SCHEMATIC PLAN

FRA-71-14.36

Ohio DOT Workspace
70171 West Interchange 6R
www.mscconsultants.com

ELEVATION ALONG BACK OF WALL

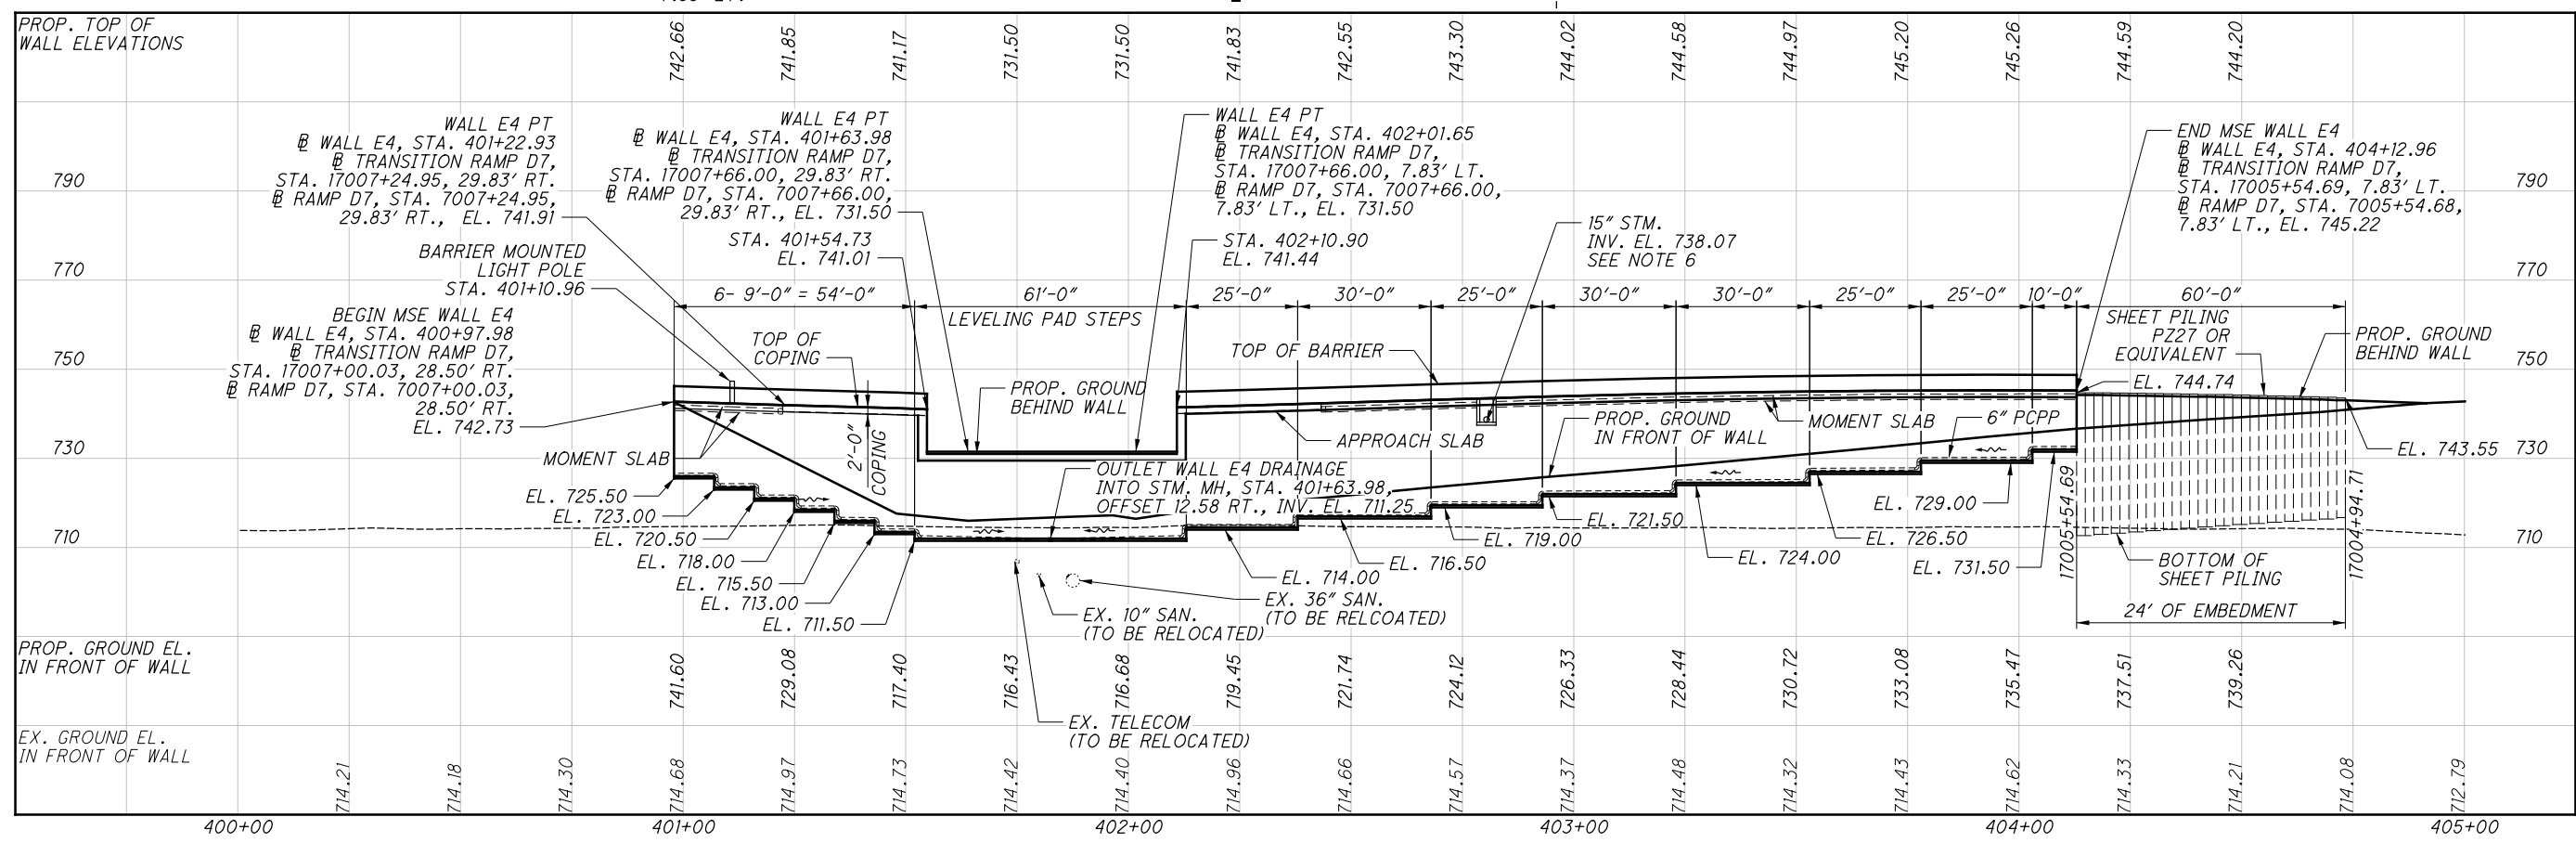
NO.	DESCRIPTION	REV. BY	DATE
1	CHANGED CONTROLLED MODULUS COLUMNS TO COLUMN SUPPORTED WALLS (CSW)	MMS	11/5/21
4	REMOVED 3'-0" DIMENSION & UPDATED CALLOUT	MMS	11/24/21

- GROUND IMPROVEMENT SHALL BE IN THE FORM OF CSW COLUMNS AND DENSE GRADE AGGREGATE LOAD TRANSFER PLATFORM (LTP). THE BOTTOM 1'-0" OF THE LTP IS CONSIDERED A WORKING PLATFORM. FOR ADDITIONAL INFORMATION, SEE NOTES FROM SHEET 842. FOR SECTION VIEWS, SEE SHEET 851.

SCHEMATIC SOLDIER PILE WALL - ELEVATION

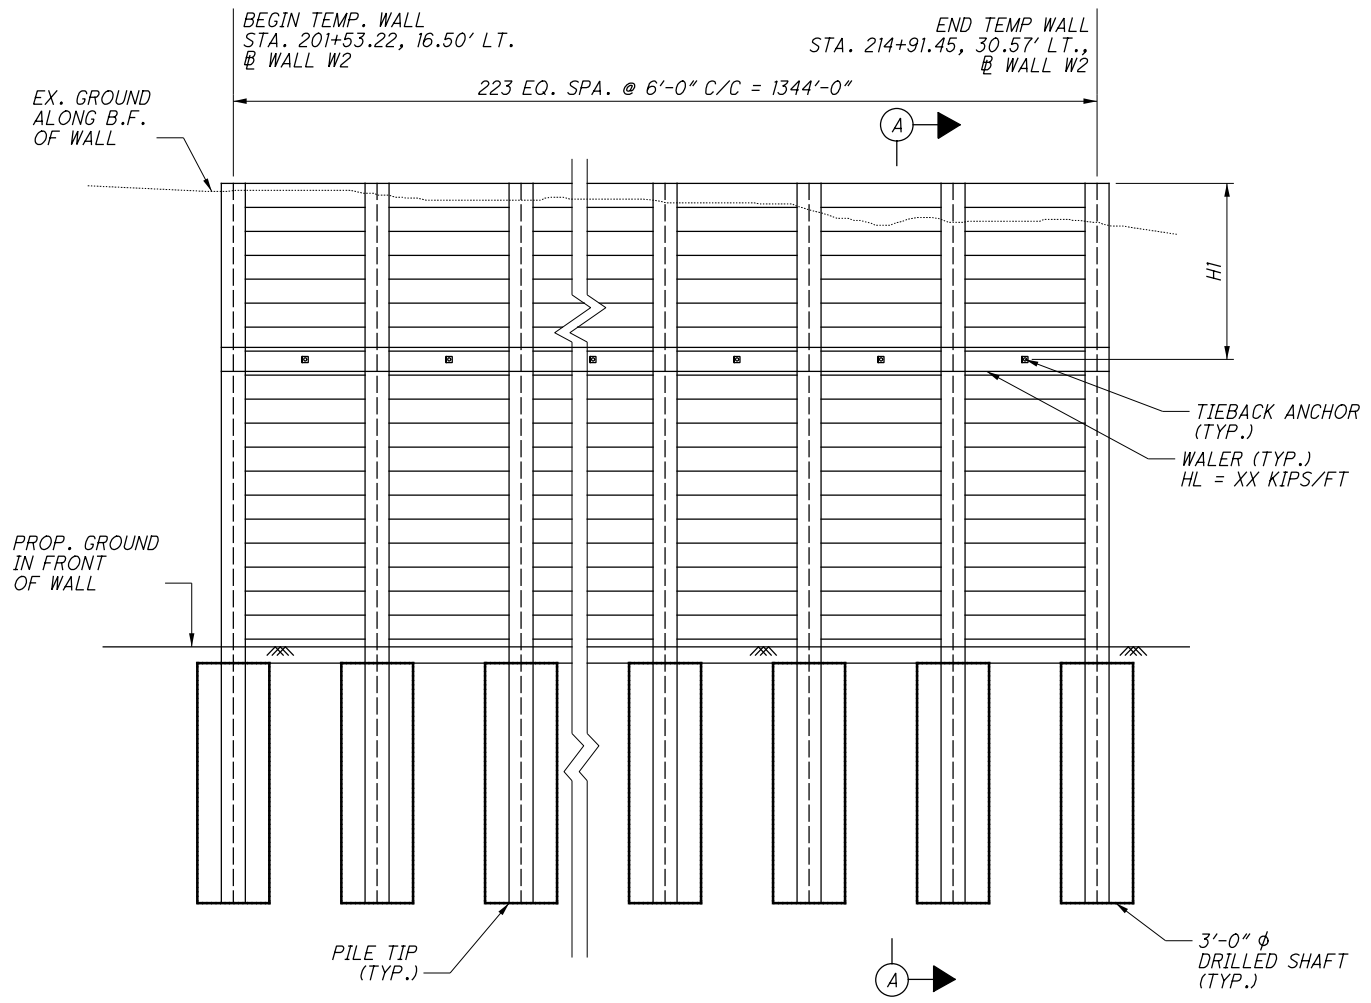
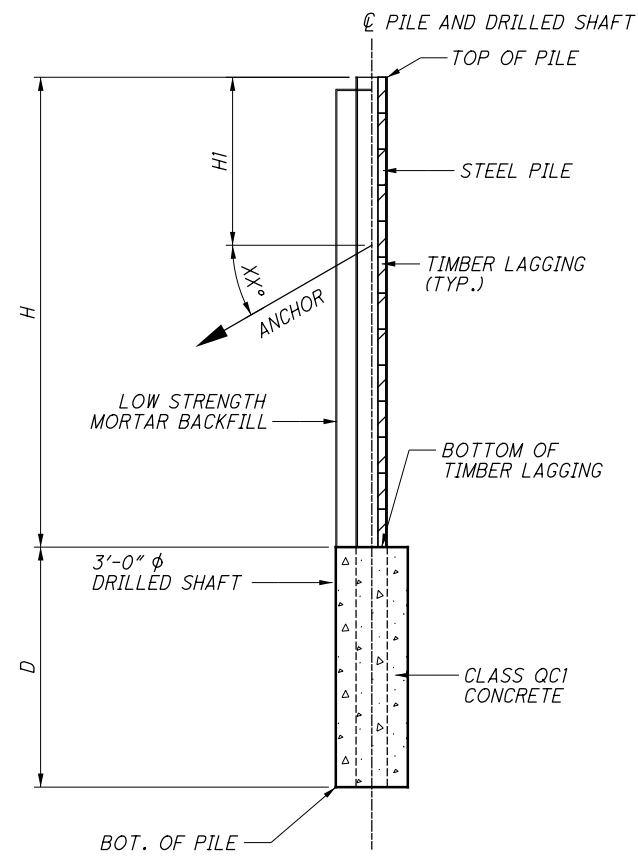
NO.	DESCRIPTION	REV. BY	DATE
4	CHANGED CLASS QC1 CONCRETE TO LOW STRENGTH MORTAR	MMS	11/22/2021
4	CHANGED CLASS QC4 CONCRETE TO CLASS QC1 CONCRETE	MMS	11/22/2021

EAST SIDE

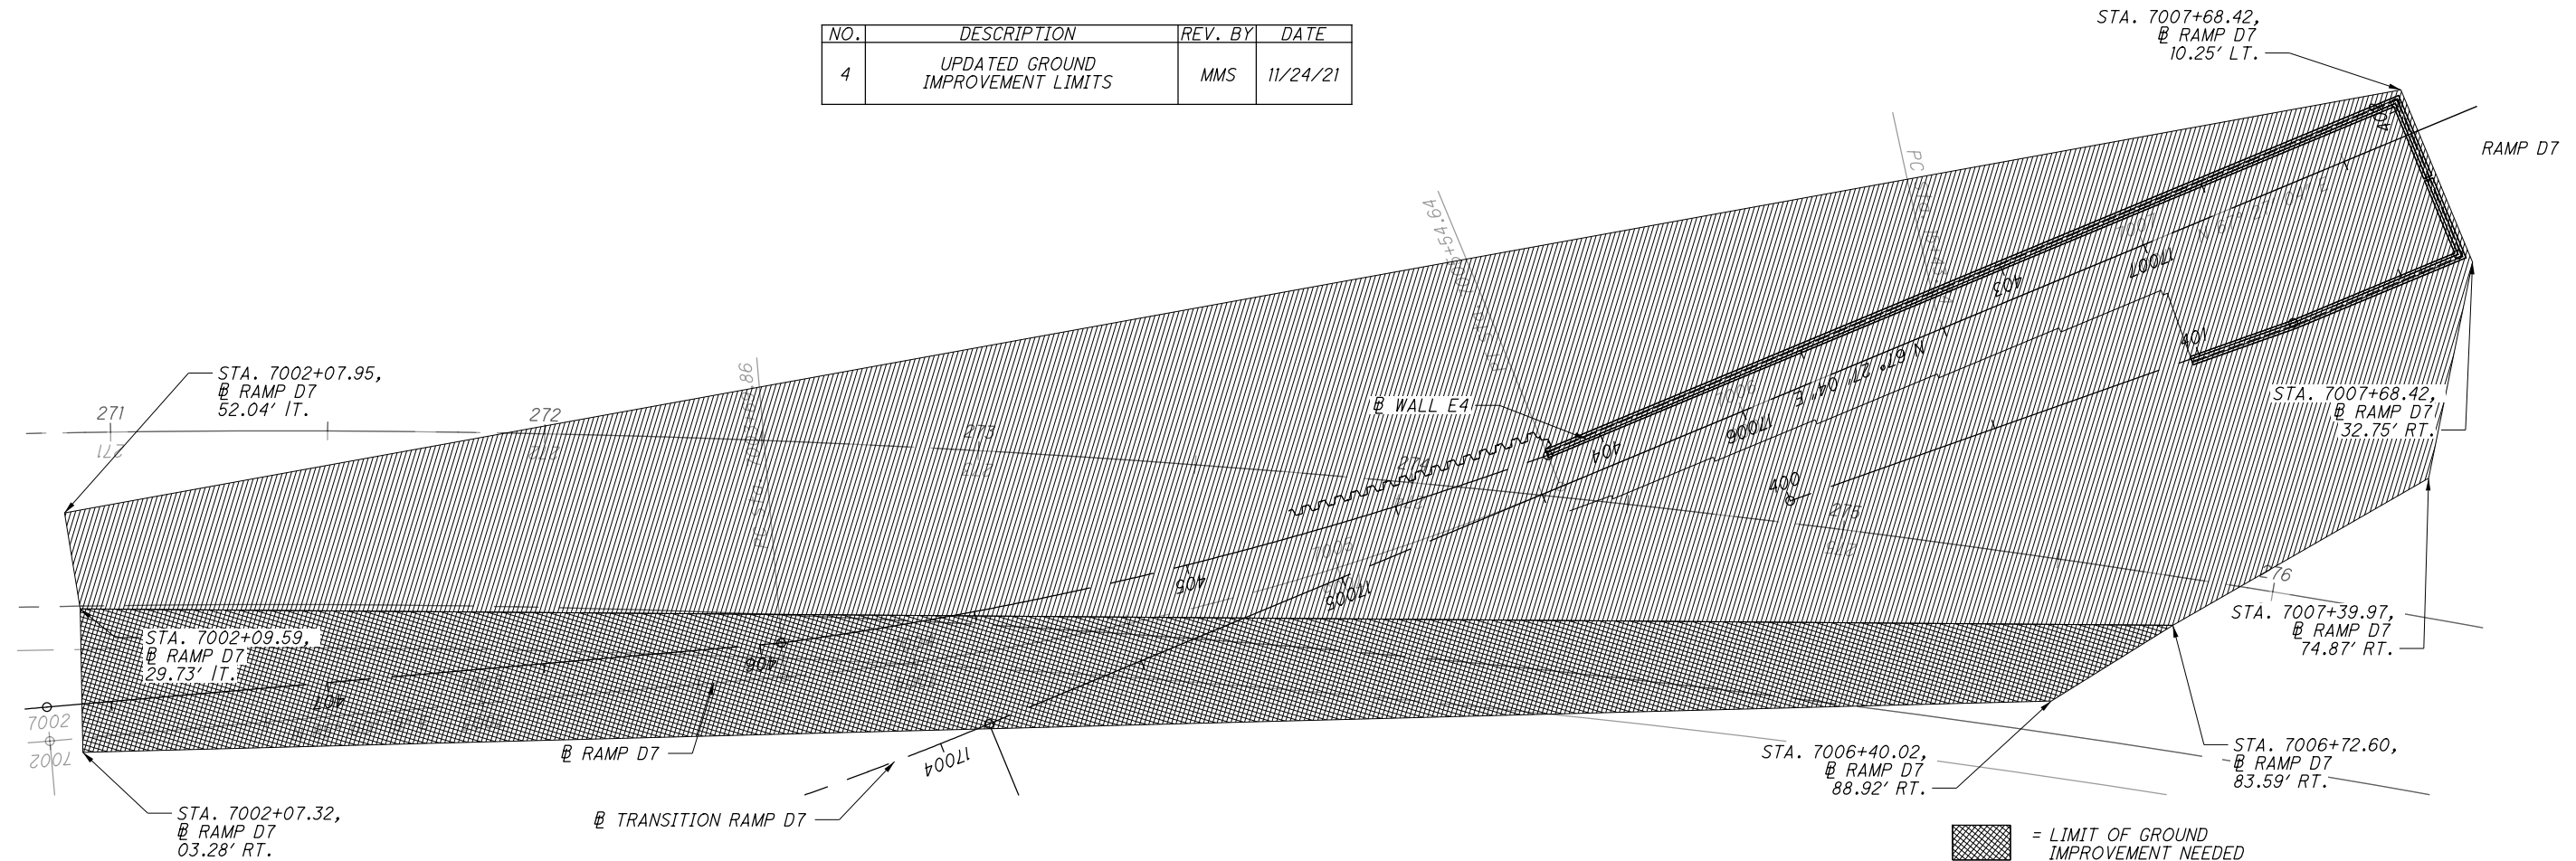
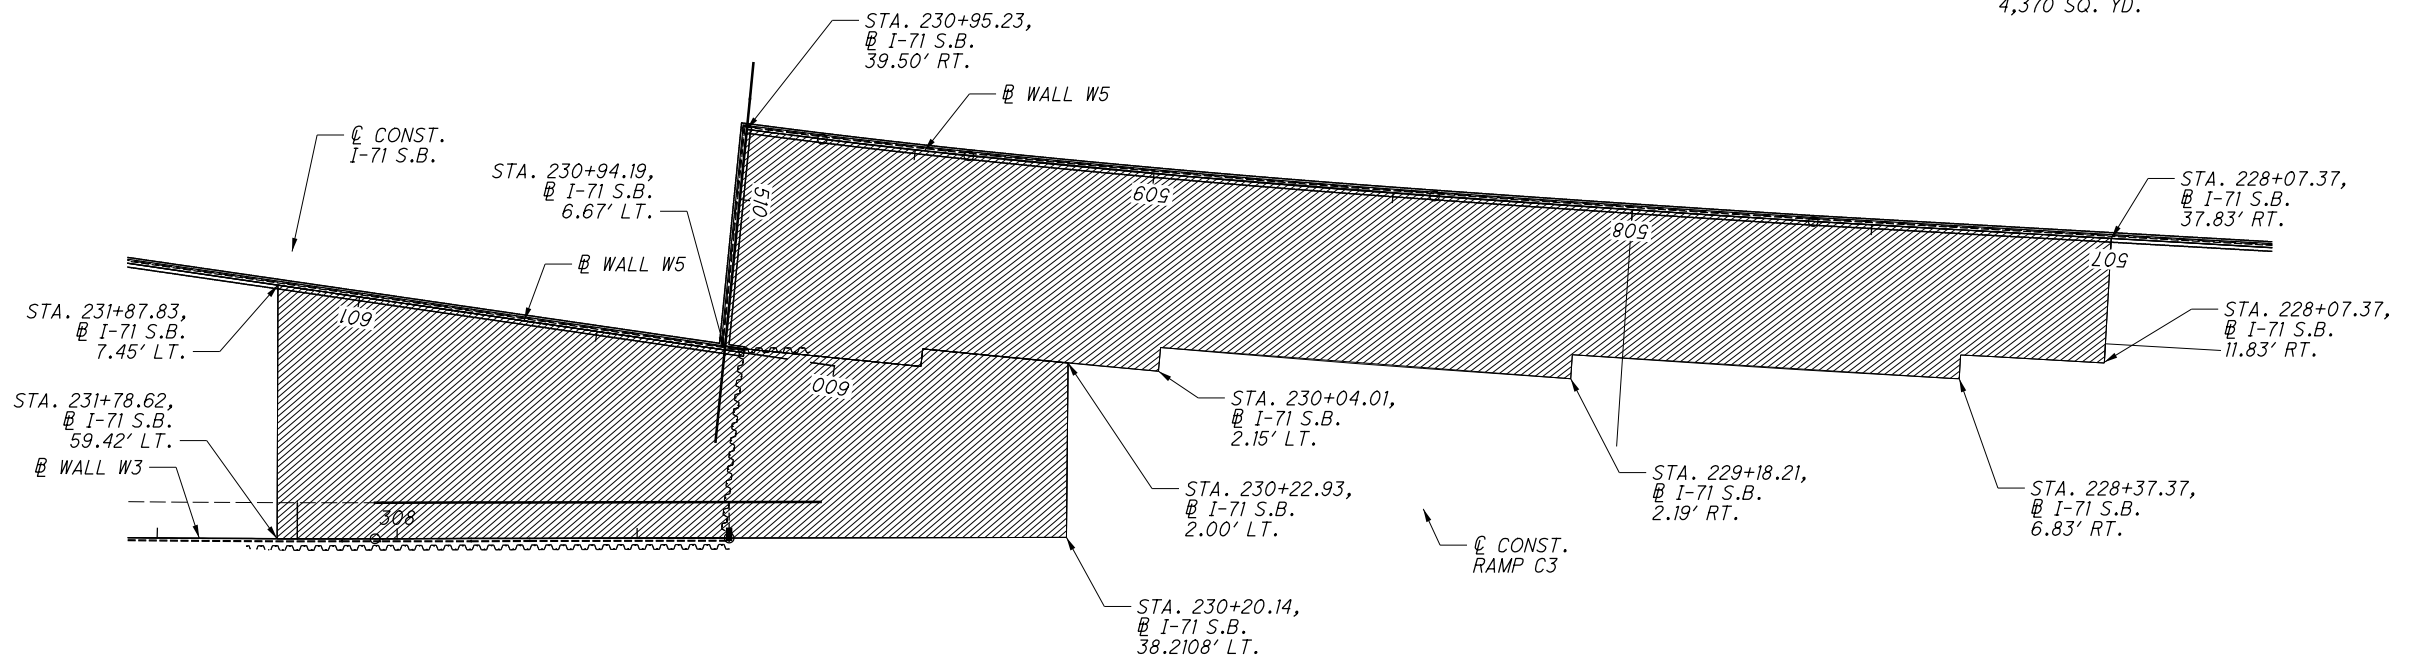
NO.	DESCRIPTION	REV. BY	DATE
4	UPDATED GROUND IMPROVEMENT LIMITS	MMS	11/24/21

-  = LIMIT OF GROUND IMPROVEMENT NEEDED OVER EXIST. I-70 EMBANKMENT: 1310 SQ. YD.
-  = LIMIT OF GROUND IMPROVEMENT NEEDED: 4,370 SQ. YD.

ELEVATION LOOKING UPSTATION
 PIER 13 SHOWN
 DRILLED SHAFTS AND REINFORCING NOT SHOWN

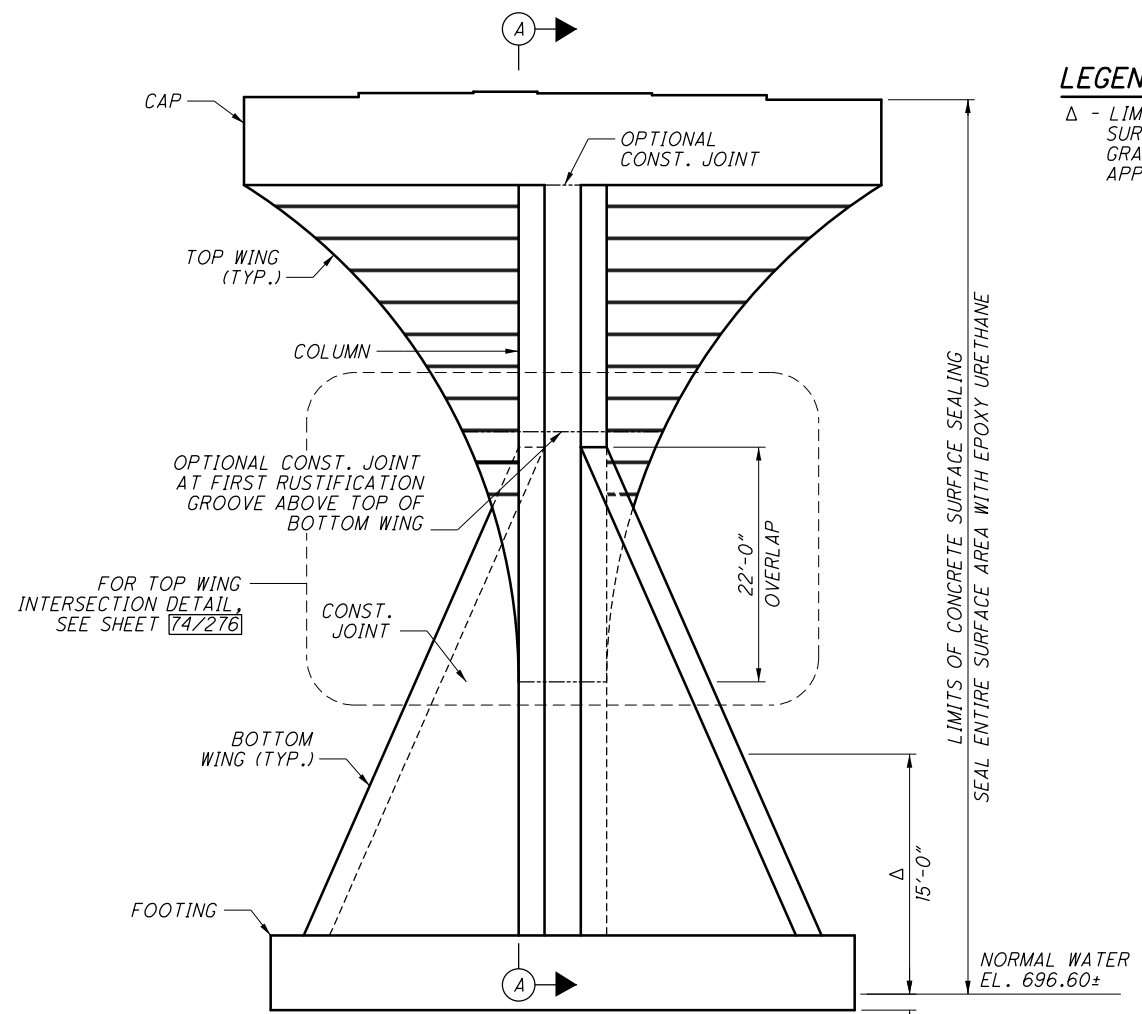
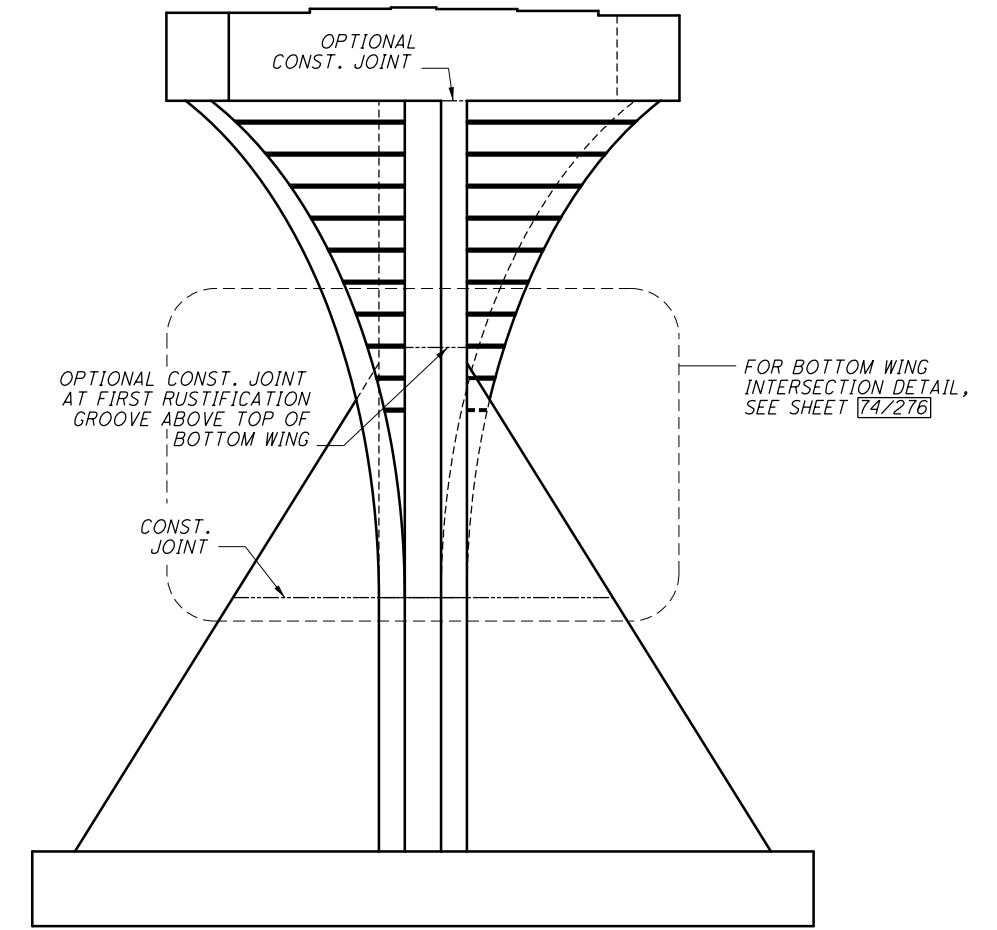
NO.	DESCRIPTION	REV. BY	DATE
4	ADDED OPTIONAL CONSTRUCTION JOINT	DBL	11/23/21

BOTTOM PLAN
TOP PORTION OF PIER NOT SHOWN

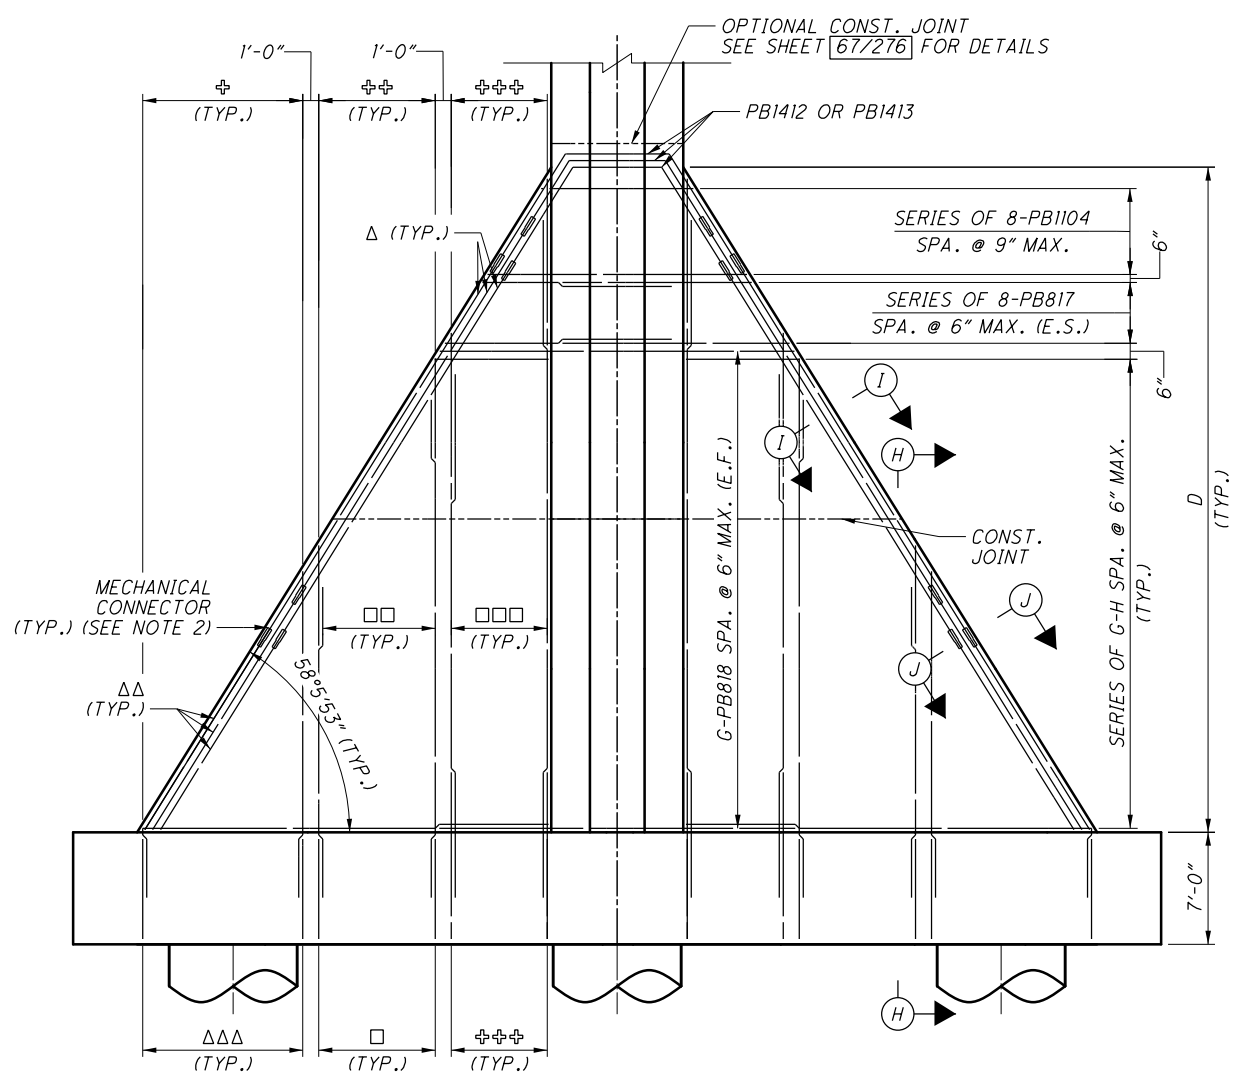
NO.	DESCRIPTION	REV. BY	DATE
4	ADDED OPTIONAL CONSTRUCTION JOINT	DBL	11/23/21
